GOVERNMENT OF TELANGANA
FOREST DEPARTMENT

Rc. No. 1011/2020/S4, Dated. 24.08.2023.

Sub:- TSFD- F(C) Act, 1980- DPRE KB Asifabad- Diversion of **2.6325 Ha (Revised from 4.1083 Ha)** of Forest land for BT Road from **"R/F PWD Road to Jhaduguda (PWD Road to Kishan Thanda)** in Bheempur Block, Asifabad forest Division of Komurambheem Asifabad District in favour of District Panchyath Raj, Engineer (PIU), Komarambheem- Asifabad District- Additional documents/clarification called for - Submitted- Regarding.

Sub: - DPRE, PIU, KB Asifabad – PMGSY – Forest Clearance – Diversion of 2.6325 ha of forest land in Asifabad division for Laying of BT Road from PWD Road to Jhaduguda of Jainoor Mandal of Komarambheem Asifabad District in favour of PR Dept; Asifabad District (Proposal No. FP/TG/ROAD/44770/2020) – Submission of EDS data – request to take necessary action – reg.

Scale 1:50,000
Sheet No. 56

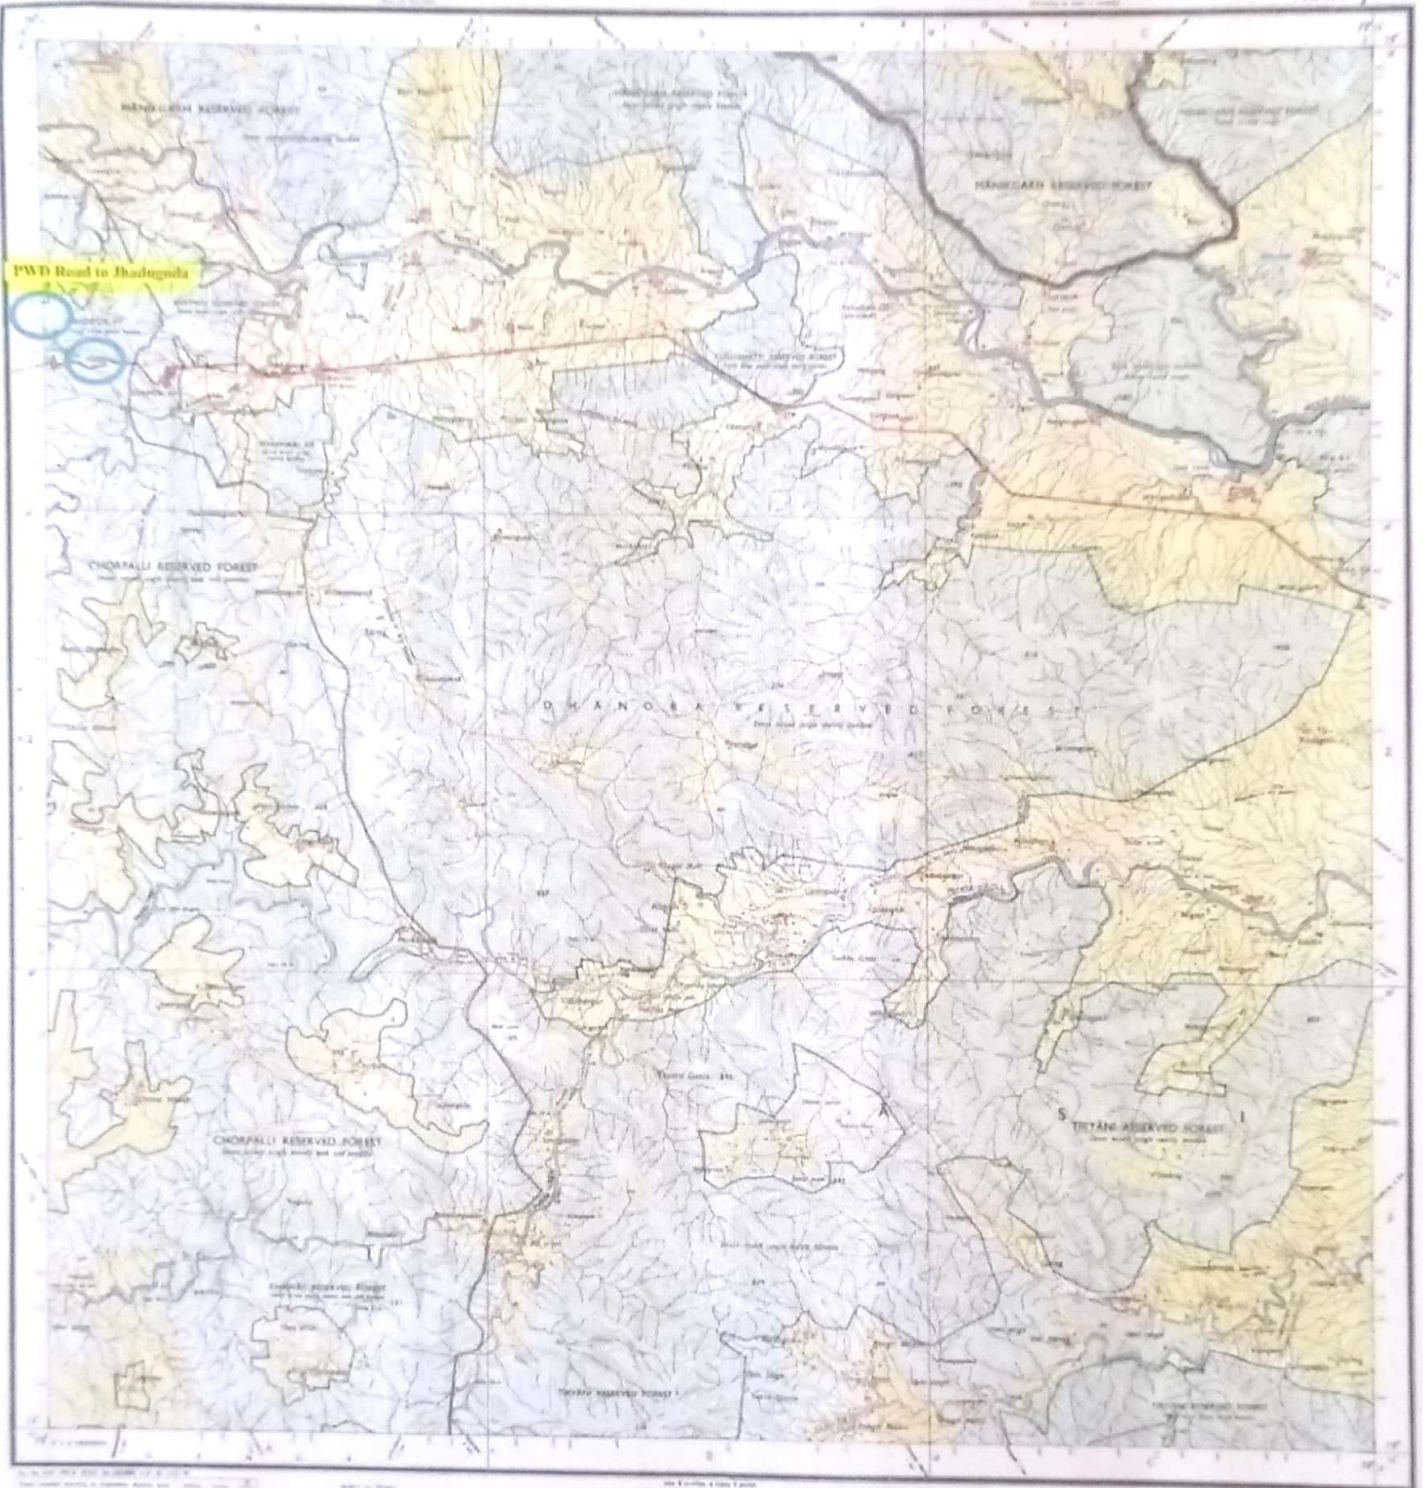
(ii)	Proper documentary evidence like RF notification etc., on existing road i.e., RoW allowed or otherwise, if allowed, actual length and width of the road allowed etc., shall be submitted.	The proposed road is passing through RF Bheempur. There is no explicit mention about RoW for these RF block in the available gazette notification and other documents.

1. From the toposheet, it can be seen that there are 7 bridges/culverts proposed in the forest land. However, the forest land proposed for diversion in such places is only 7.5 m in width only. Specific comment is requested from the UA on whether construction of bridges/culverts is possible in the 7.5 m width proposed for diversion without breaking up the adjacent forest land not proposed for the diversion.

As per 1980 and it is mapped on SOI (Map sheet No. 56M/4 is surveyed in 1975-76 in first edition 1982) is submitted that there was an existing cart track for an length of 1400 mtrs only out of 3510 mtrs and same is submitted herewith.
(iii)	From the Toposheet, it can seen that there are 7 brides/culverts proposed in the forest land. However, the forest land proposed for diversion in such places is only 7.5 m width only. Specific comment is requested from the UA on whether construction of bridges/culverts is possible in the 7.5 m width proposed for diversion without breaking up the adjacent forest land not proposed for the diversion.	It is submitted that, the User agency i.e., District Panchayat Raj Engineer, Kumarambheem Asifabad vide reference 2 nd cited above has submitted that, Seven (07) number of culverts are proposed with 7.50 mts width in the forest land which is enough for construction of Seven (7) number of culverts.

1. Seven (07) number of Culverts are proposed with 7.50 Mts width in the forest land which is enough for construction of Seven (07) number of Culverts.
